STAFF REPORT

Agenda Title: For Possible Action: To approve a Tentative Subdivision Map request from G&E Investments, LLC (property owners: Gordon Street, LLC and G&E Investments, LLC) for 16 single family attached residential units in a Common Open Space Development on property zoned Multi-Family Apartment (MFA) within the Brown Street Specific Plan Area (BS-SPA), located at 1709, 1725, 1759 and 1809 N. Edmonds Drive, APNs 008-306-09, -11, -15, and -16. (TSM-17-052) (Susan Pansky, spansky@carson.org)

STAFF REPORT FOR THE PLANNING COMMISSION MEETING OF MAY 31, 2017

**Engineering Division
Planning Commission Report
File Number TPUD-17-052**

NORTH EDMONDS-COMMON OPEN SPACE DEVELOPMENT
CARSON CITY, NEVADA
UTILITY PLAN

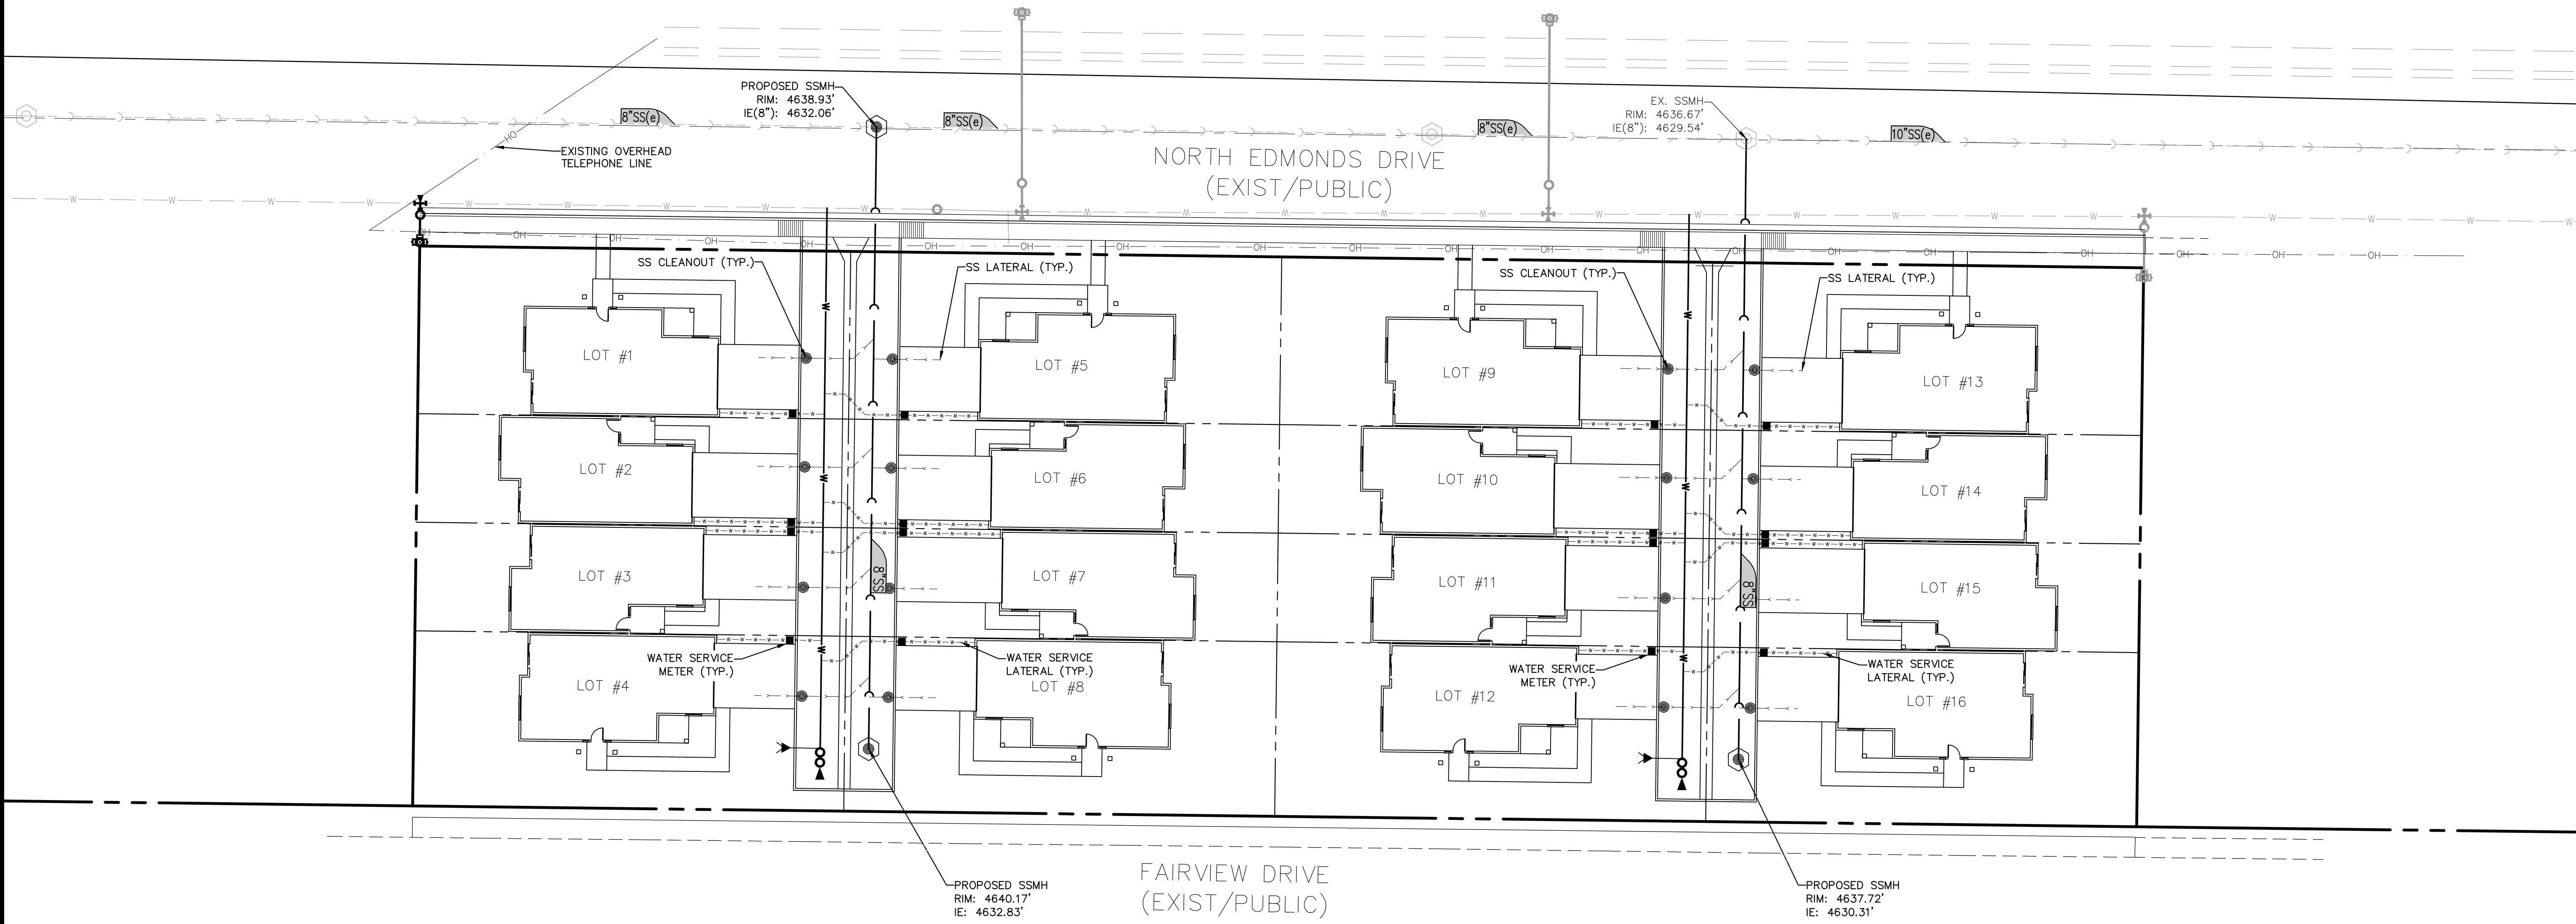
If these are detached structures I have no comment, if attached the map needs to clearly allow the utilities in the common area.

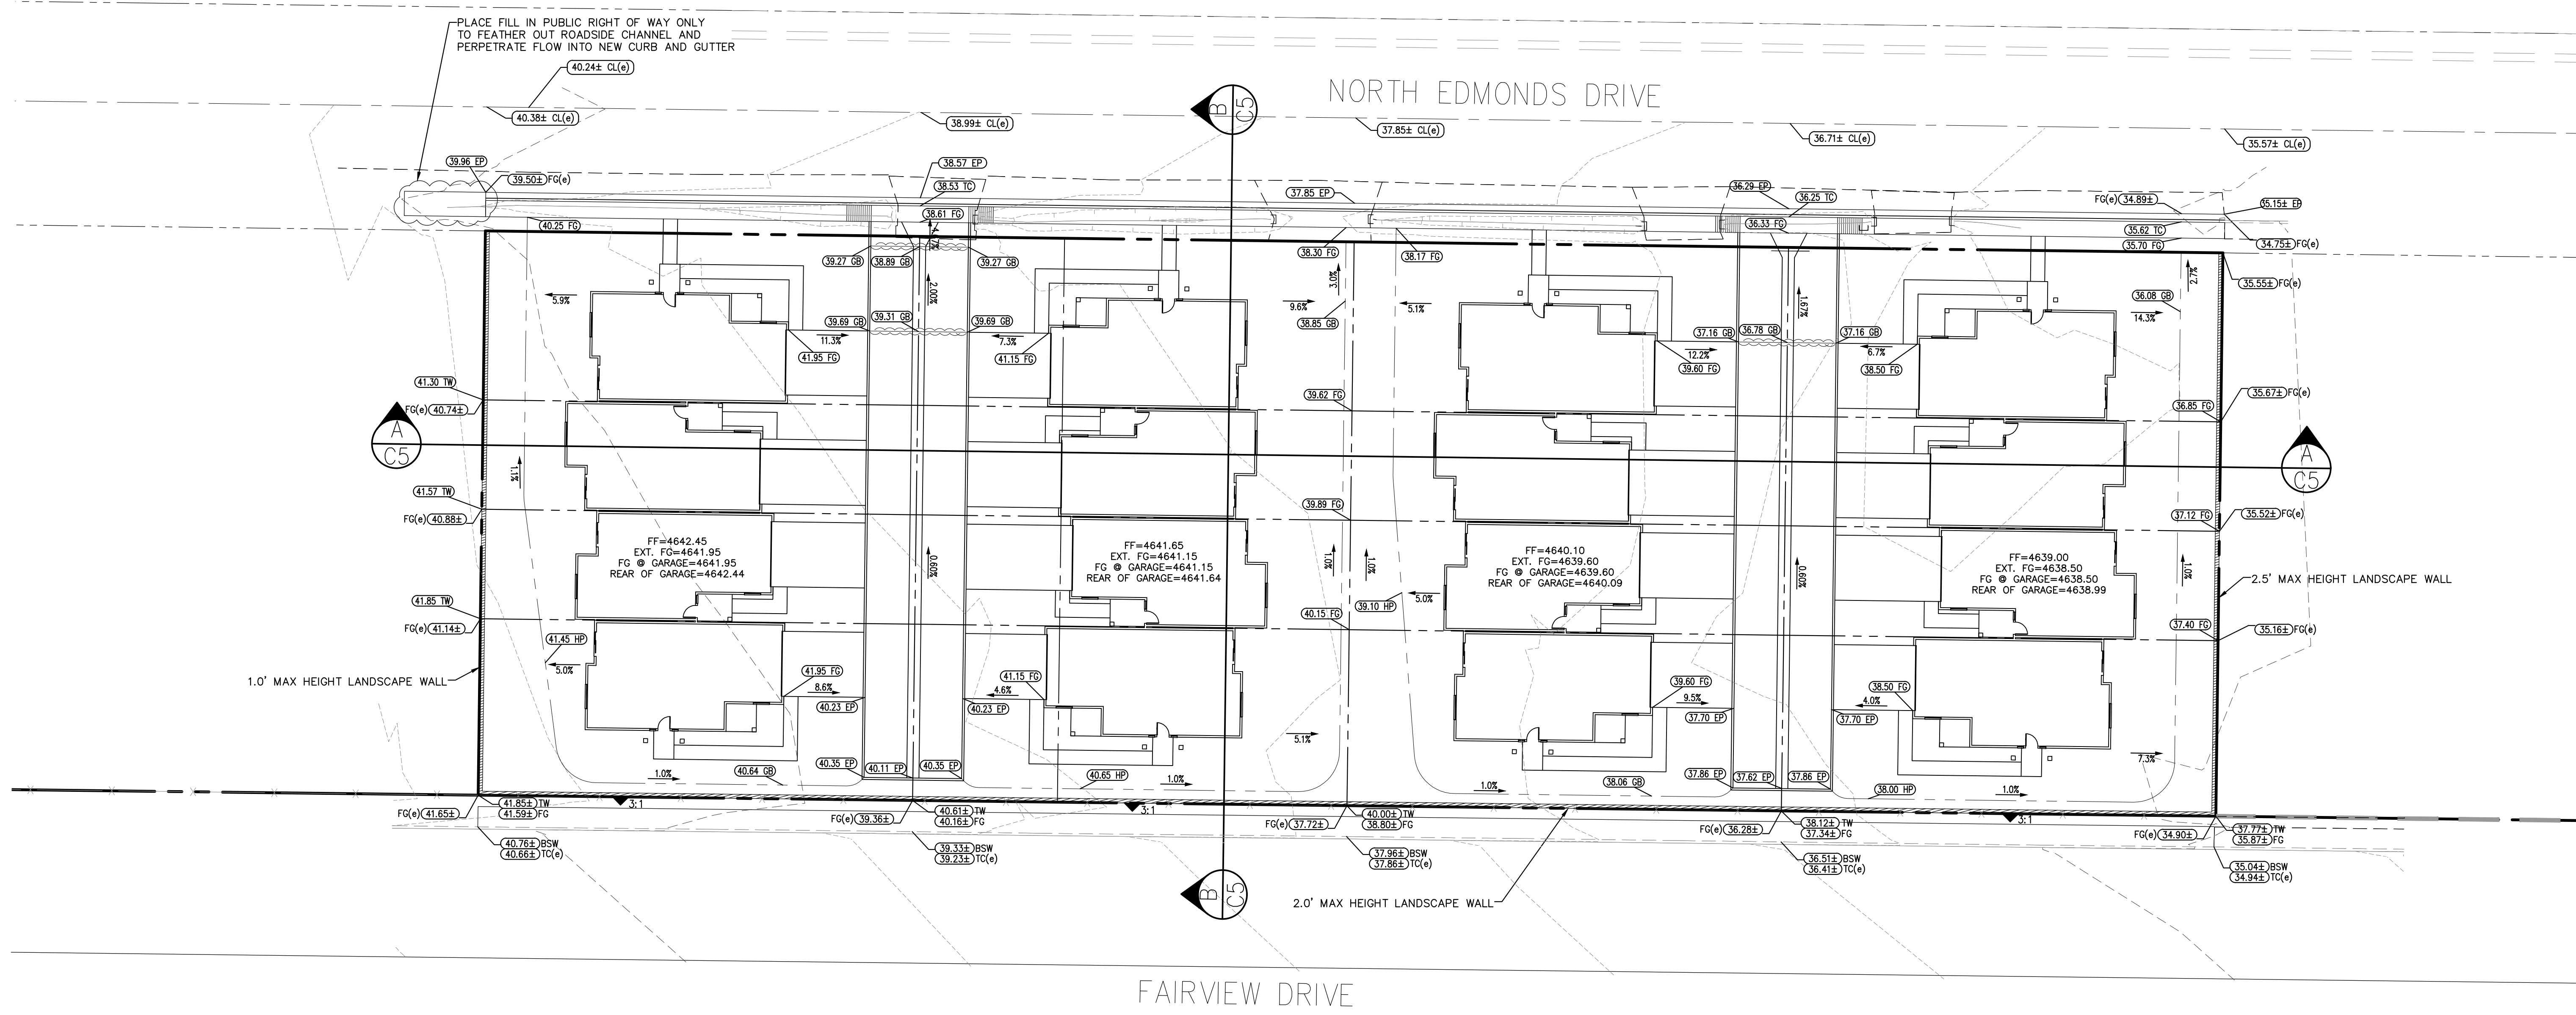
3. The N Edmonds Drive street section along the frontage must be upgraded to the standard roadway section for urban streets with on street parking and 5 foot sidewalks (CCPW Standard Detail #C-5.1.9), per the Specific Plan Area requirements. This requirement includes repaving half of the street along the property frontage.

- The N Edmonds Drive street section along the frontage must be upgraded to the standard roadway section for urban streets with on street parking and 5 foot sidewalks (CCPW Standard Detail #C-5.1.9), per the Specific Plan Area requirements. This requirement includes repaving half of the street along the property frontage.
